G.O., No. 576 P.

Accommodation Accepting the proposals
of the Collector of N. Arcot regarding
the additional — required at the
plague camp at Arkonam

Submitting a plan showing the existing sheds in the plague camp at Ashoum and the additional accommodation proposed.

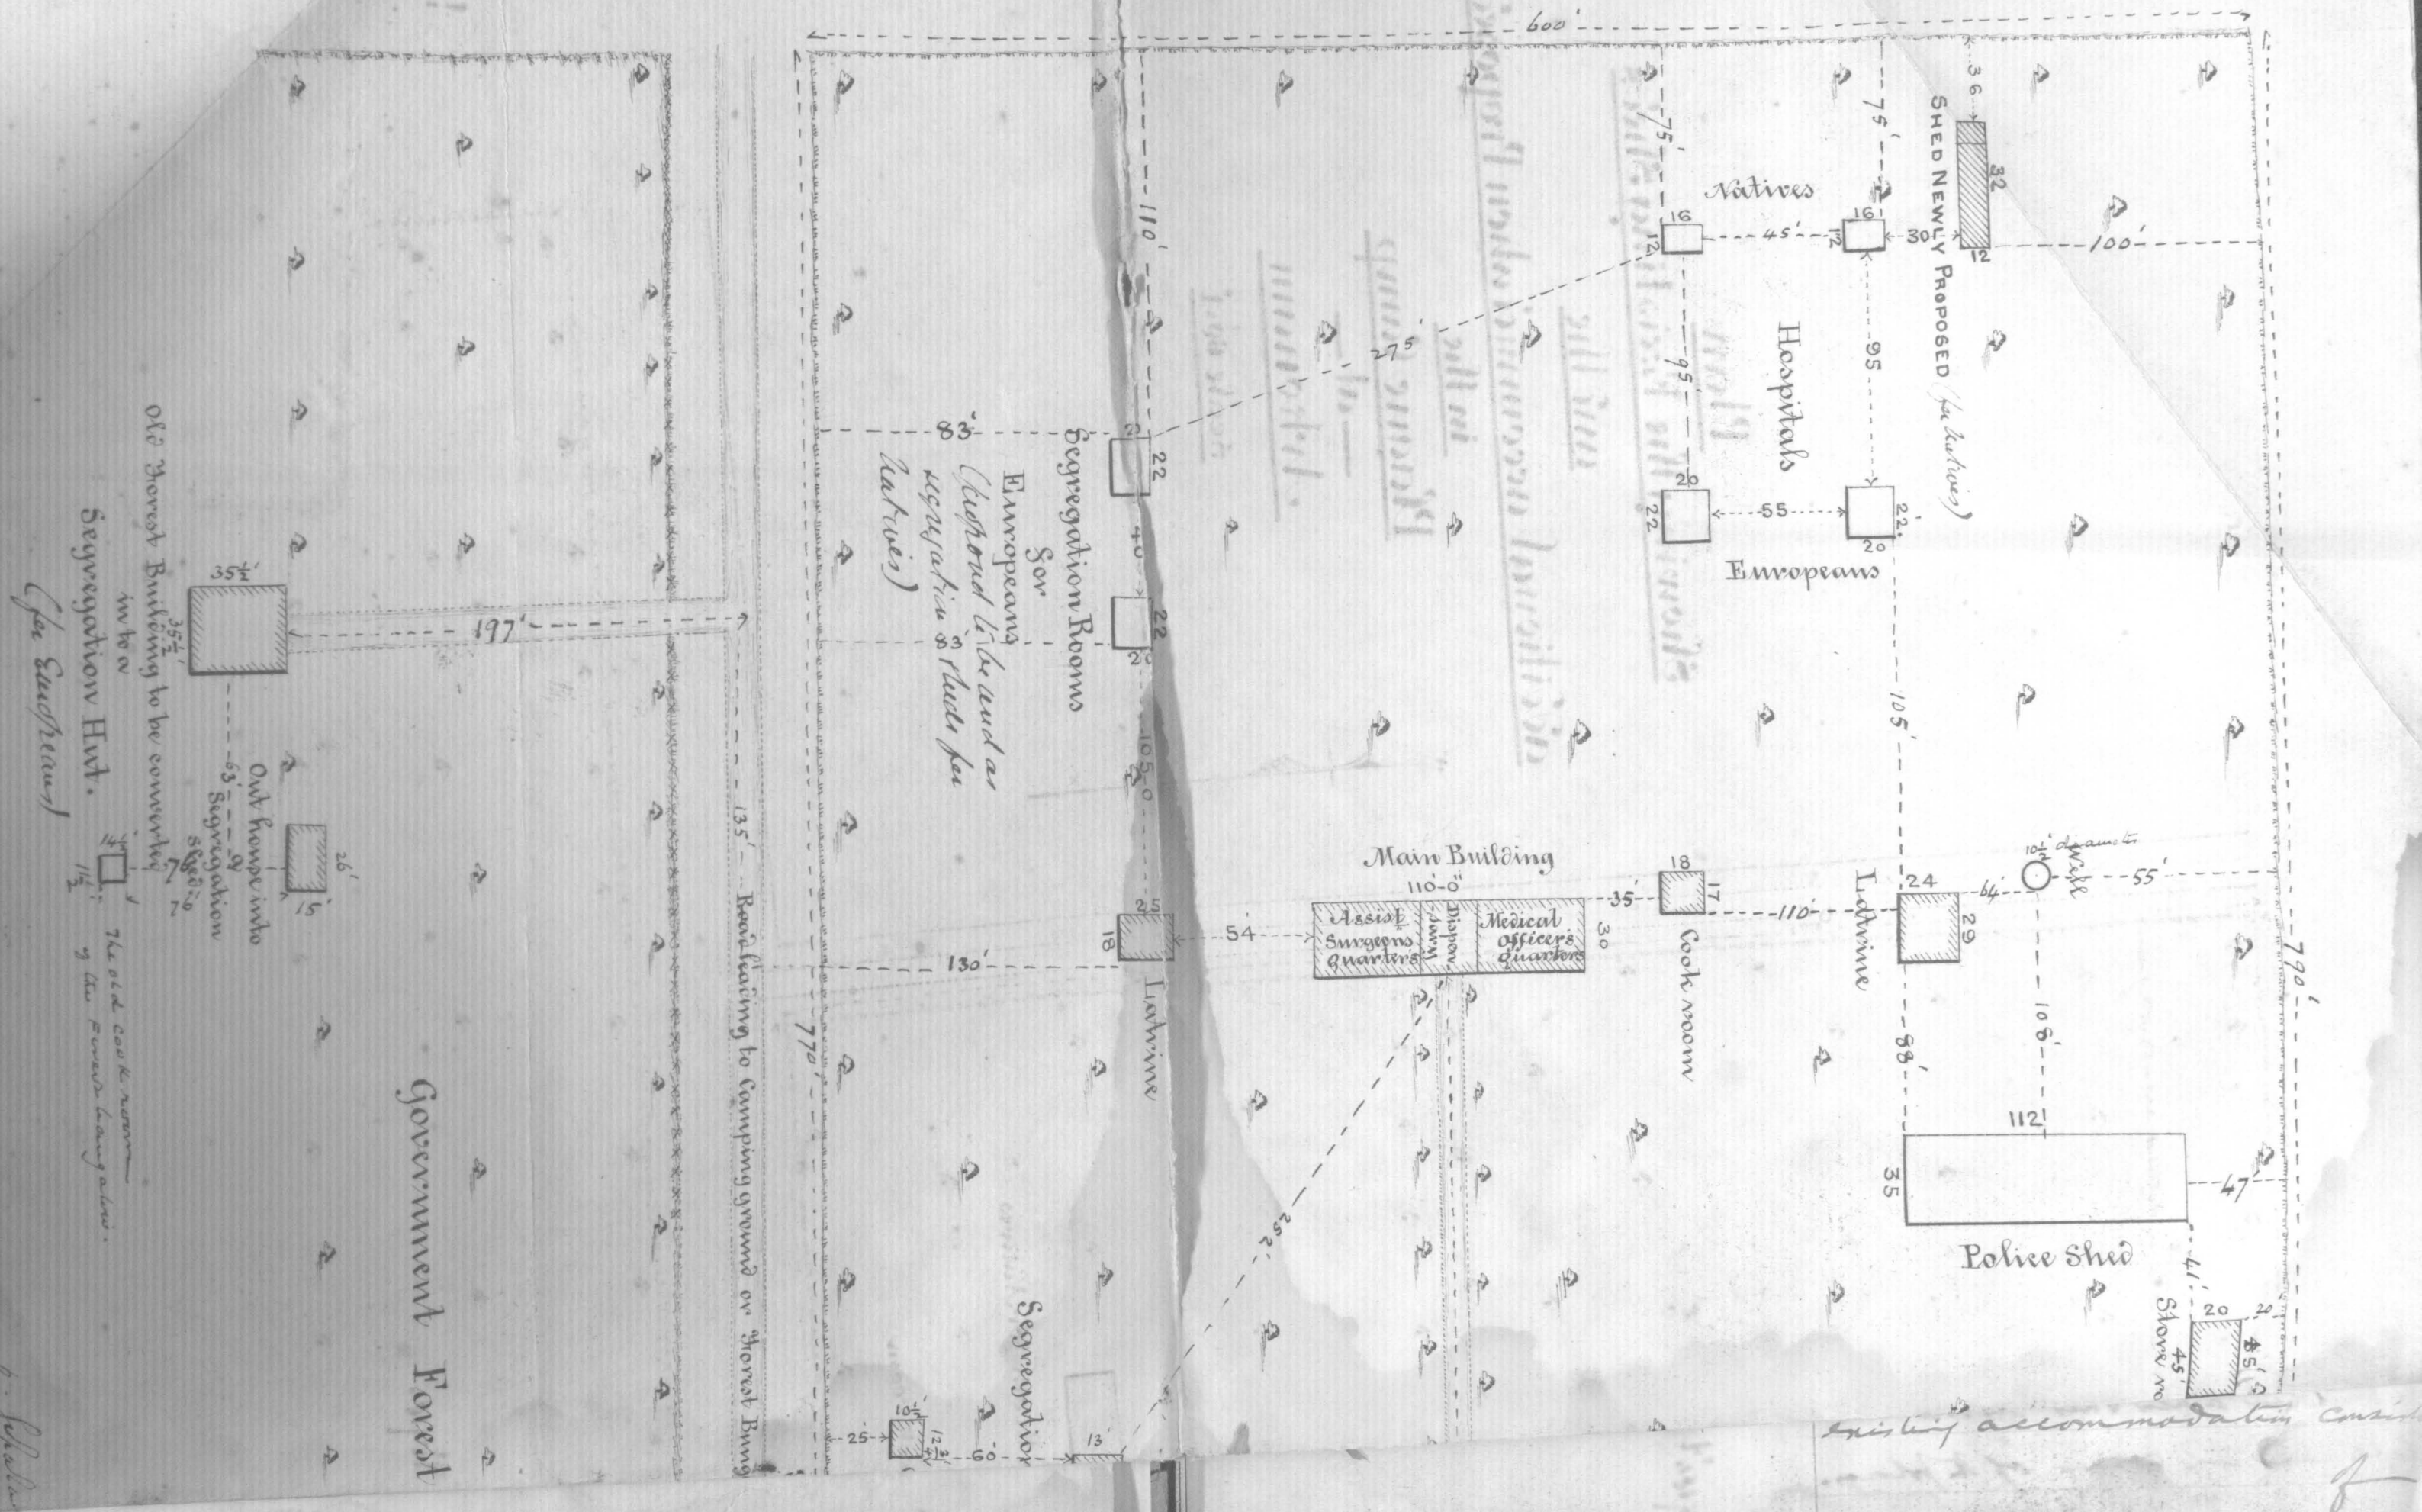
2. The dimensions of each of the
European observation sheds and Plague Sheds
are shown as 22' x 20' in the enclosed
plan. Each of these Sheds has, however,
a verandah attached to it, and after
deducting the area covered by the
verandah, the area available for
occupation is 236 sq. feet in each

The building already used for the segregation of natives is divided into two compartments by a partition wall, one compartment for males and the other for females. The compartment used by males contains a superficial area of 330 sq. feet and that used by females 216 sq. feet with cubic spaces of 2976 feet and 1944 feet respectively. The hospital sheds (plague sheds) for natives have no verandahs and they each contain a superficial area of 192 sq. feet and a cubic space of 1728 feet.

2. From C.O. 728 P and the
plan submitted with it, ^{it appears that} the
existing accommodation consists

- (1) Shed for European males - $20 \times 22'$ or 236 sq. feet, including verandah.
- (2) Shed for European females - $20 \times 22'$ or 236 sq. feet, including verandah.
- (3) Shed for native males - $16 \times 12'$ or 192 sq. feet (has no verandah).
- (4) Shed for native females - $16 \times 12'$ or 192 sq. feet (has no verandah).

- (5) 1 Shed for natives with provision for $\left\{ \begin{array}{l} \text{males} - 330 \text{ sq. feet} \\ \text{females} - 216 \text{ sq. feet} \end{array} \right.$
- (6) 1 Shed for European males - $20 \times 22'$ or 236 sq. feet, including verandah.
- (7) 1 Shed for European females - $20 \times 22'$ or 236 sq. feet, including verandah.

vide para 1 supra - the Colls. is taking steps to double the accommodation by building a new shed $32 \times 12'$ - vide left hand top corner of the plan.

The Collr's proposals are accepted. A thatched roof ~~pro~~ affording ~~efficient~~ protection against sun and rain ^{will suffice} for the old fresh building.

for the present.
Hm
The Coll^r's proposals,
being
15/5/98 it is thought, may be
accepted.
H.T.
18 5 98
